TECHNICAL BULLETIN

MODEL/DERIVATIVE:
MINI

No: 0012
Ref: R0809bu
Issue: 2
Date: 26.07.95

PROBLEM:
OIL LEAK FROM EXTERNAL OIL PIPE CONNECTION - OLIVE

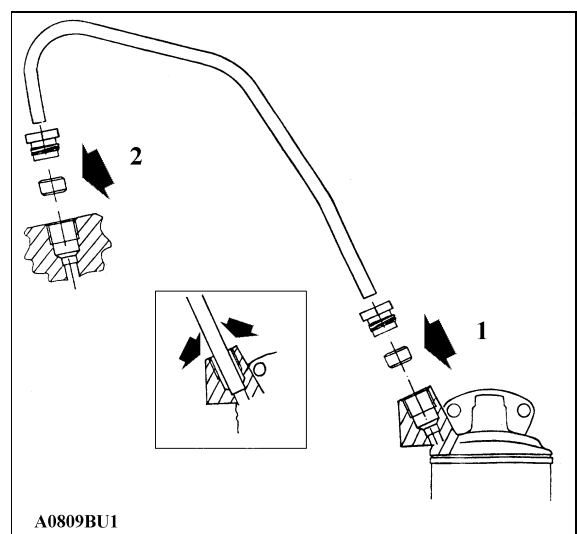
Oil leaking from external oil pipe to cylinder block via tube nut connection.

CAUSE:
Torque relaxation of tube nut

Remove external oil pipe completely, dismantle to retrieve tube nuts, discard pipe and both rubber seals.

Completely clean cylinder block, filter housing and tube nut mating threads.

Assemble new pipe part number LQP10033 and original tube nuts with new rubber seal part number LZB10017 to filter end (1 in illustration), and modified aluminium olive part number LZV100080 to cylinder block end, (2 in illustration).

Fit oil pipe to block and oil filter housing, ensure pipe is fully inserted into cavity recesses (see illustration inset), engage tube nut threads and apply "Loctite Lock'N Seal 242" to exposed threads and tighten tube nuts by hand alternating 1/4 turn at a time so as to avoid over stressing pipe in any one direction.

Finally tighten each tube nut with a suitable open ended spanner .

When tight, the underside of the tube nut at the filter head end will make contact with housing, unlike the block end which is now prevented from making contact with block face due to the aluminium olive which does not compress.
